**mps limited**  
29 Chamberlain Street  
Grey Lynn,  
Auckland 1021  
www.mps.net.nz

## Whenuapai Business Park – Stormwater Peer Review

### **Whenuapai Business Park Plan Change - Request for Further Information (RFI) Peer Review**

**Figure 4: 162 Brigham Creek Road – Flood Extents downstream of PCA1**

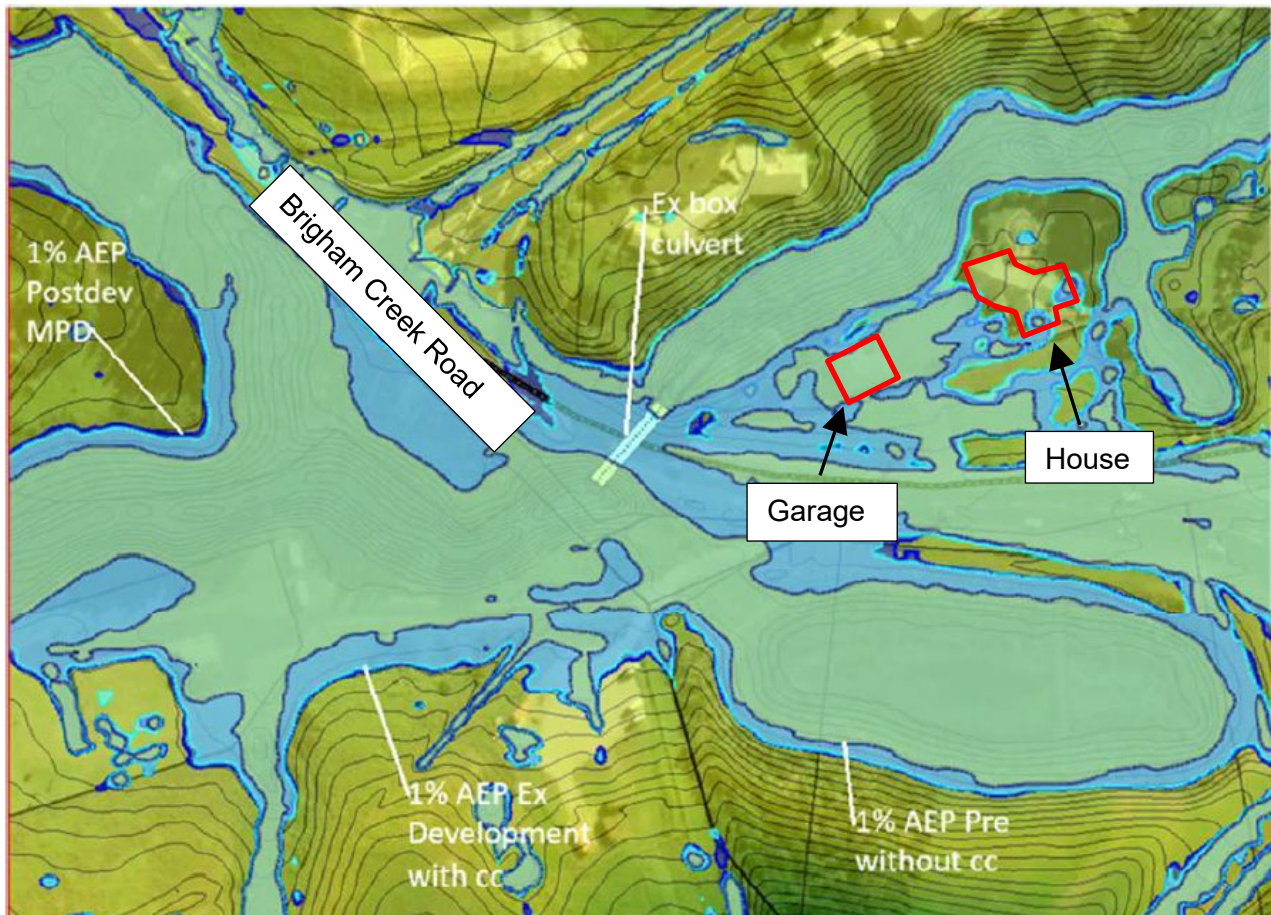
Downstream of PCA1, there are two buildings located at 162 Brigham Creek Road identified as being within at risk of flood waters identified in Figure 4 below. No habitable building floors have been identified to be affected further downstream of PCA2 as the flow will be contained within the stream channel or riparian margin.

Figure 4 above shows the relative extents of the 1%AEP storm event as follows:

- Pre-development without climate change.
- Pre-development with climate change.
- Post-development with climate change.

The results show that the greatest change in flood risk is the result of climate change with negligible change in extents between the pre and post development climate change scenarios. The existing house is predominately outside the flood plain, with minor ponding located to the east and south of the building.

Information from Cato Bolam indicates that the change in flood depth (RL9.03) at 162 Brigham Creek Road from the development of the PCA remains below the habitable floor (FFL of RL9.13m) of the house, and does not change between the pre and post development scenarios as shown in Table 1 on the next page. Therefore, the flood level of the habitable floor is unaffected by the proposed development.

**Figure 5: Auckland Transport – Notice of Requirement – Brigham Creek Road**

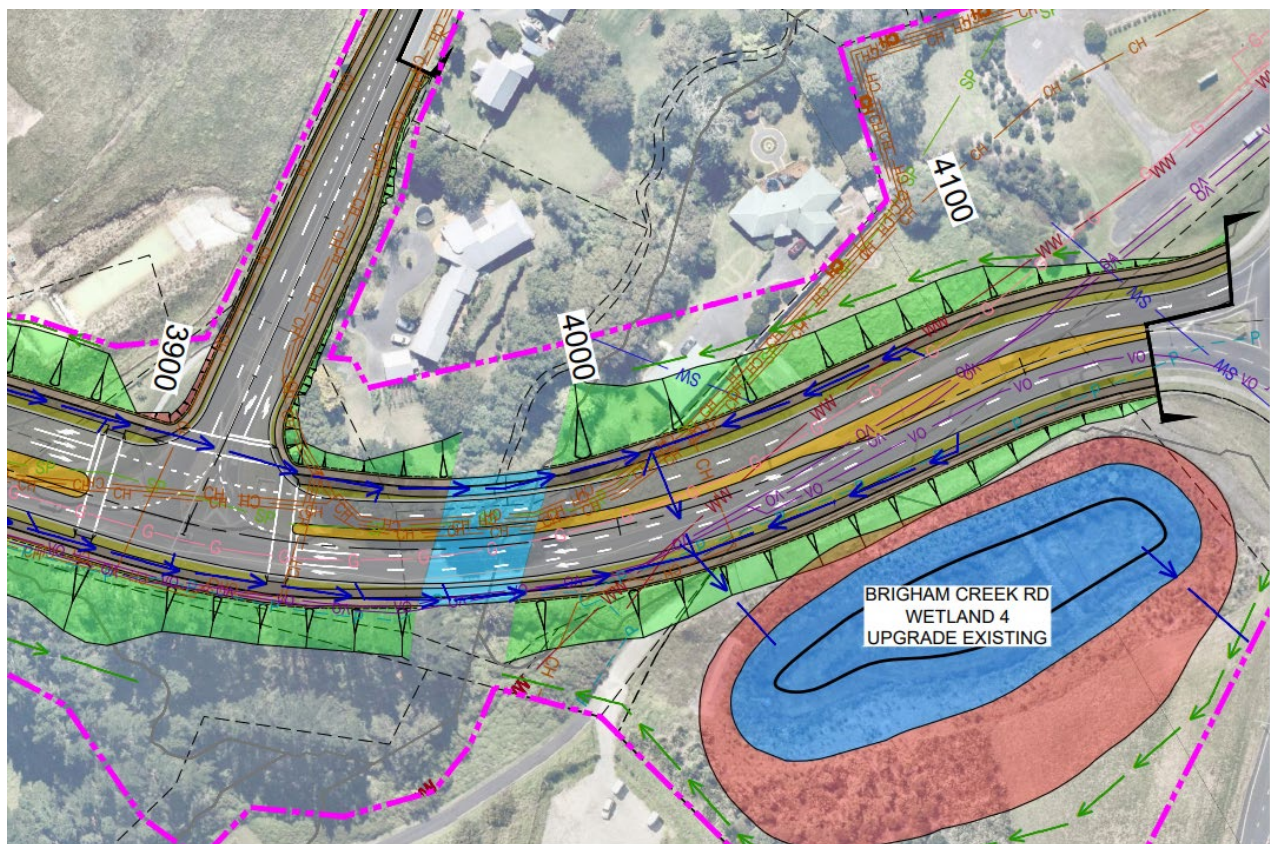
The garage at 162 Brigham Creek Road is understood to be below the fully within the flood plain with FFL of RL8.54m but is not deemed a habitable floor. However, Auckland Transport has lodged a Notice of Requirement (NoR) over this portion of the property that includes the garage, refer Figure 5 below. Auckland Transport propose to use this area to batter the widened road, so the garage will be removed.
